UNITED STATES PATENT AND TRADEMARK OFFICE

Office Action Summary	Application No. 10/033,216	Applicant(s) LONG, ROBERT T.	
	Examiner Basil Katcheves	Art Unit 3635

DETAILED ACTION

FIG. 1

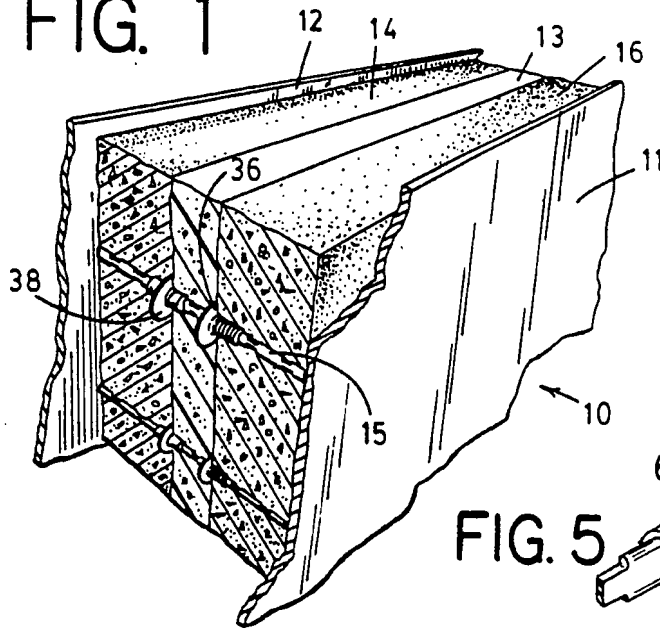
Regarding claims 25 and 29, Long discloses a wall panel comprised of insulation (fig. 2: 13) spaced between concrete layers (fig. 2: 14 & 16), having a plurality (fig. 1) of elongated connectors extending through the insulation layer and having opposite ends embedded in the concrete layers, wherein each connector has non-colinear (see marked figure) longitudinally extending portions (fig. 4: 21 & 28), laterally (linearly) spaced apart and connected by an internal web (fig. 4: 20) of thinner or equal thickness. Long also discloses each connector as having first and second anchorage surfaces (fig. 4: 22 & 31) capable of transferring forces along the longitudinal portions.

Regarding claims 37 and 38, Long discloses a wall panel comprised of insulation (fig. 2: 13) spaced between concrete layers (fig. 2: 14 & 16), having a plurality (fig. 1) of elongated connectors extending through the insulation layer and having opposite ends embedded in the concrete layers, wherein each connector has parallel longitudinal extending portions (see marked figure; fig. 4: 21 & 28), laterally (linearly) spaced apart and connected by an internal web (fig. 4: 20) of thinner or equal thickness. Long also discloses each connector as having first and second anchorage surfaces (fig. 4: 22 & 31) capable of transferring forces along the longitudinal portions.

FIG. 4

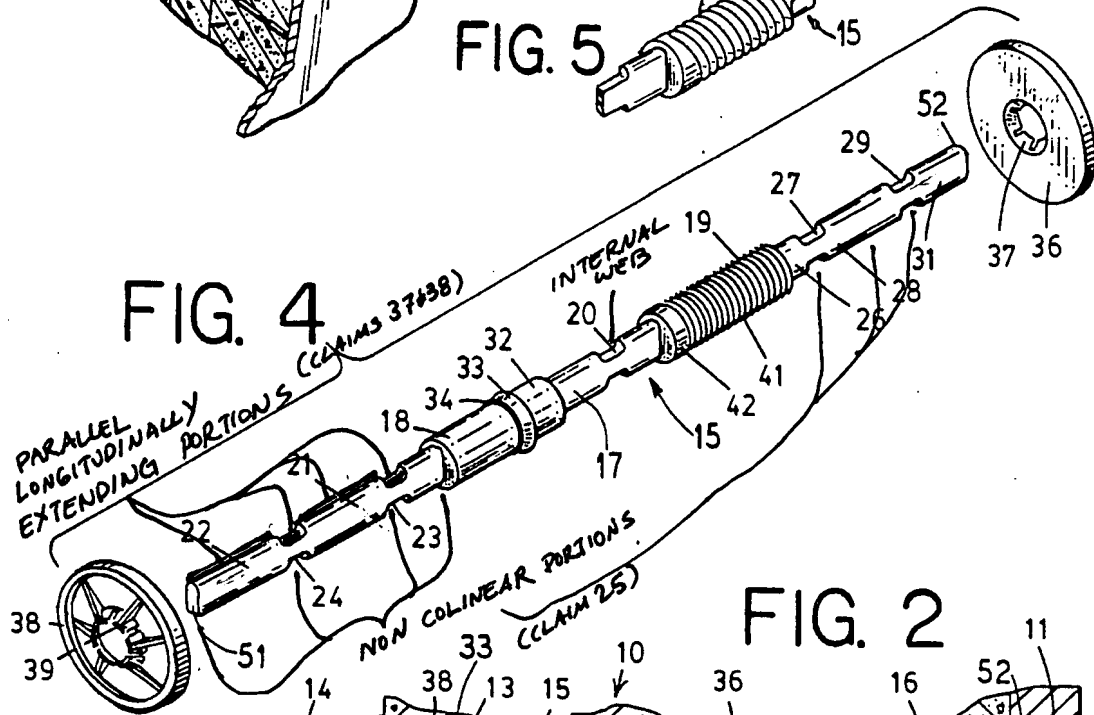
Regarding claims 27 and 32, Long discloses the connector as having a centrally located region comprising a perpendicularly extending lip (fig. 4: 32 & fig. 2: 36 & 38) for locating the connector within the insulation layer.

Regarding claim 30, Long discloses anchoring surfaces (fig. 4: 22 & 31) adjacent to the ends (51 & 52) which are inherently capable of transferring forces through the longitudinal portions.

Regarding claims 35 and 36, Long discloses an anchoring surface formed transversely across the longitudinally extending portion (fig. 4: components 39 & 36 occupy a plane which is transverse to the longitudinally extending portions 21 & 28).

Applicant's arguments filed 2/8/07 have been fully considered but are not persuasive. The applicant argues that the prior art does not have longitudinally extending portions that are laterally spaced. The examiner has included a drawing to more clearly show how Long contains two longitudinal sections (right and left end portions) that are spaced laterally (side by side) from each other. The applicant argues that lateral is to mean "to the side". These sections are spaced to the side and may be understood better by the attached drawing.
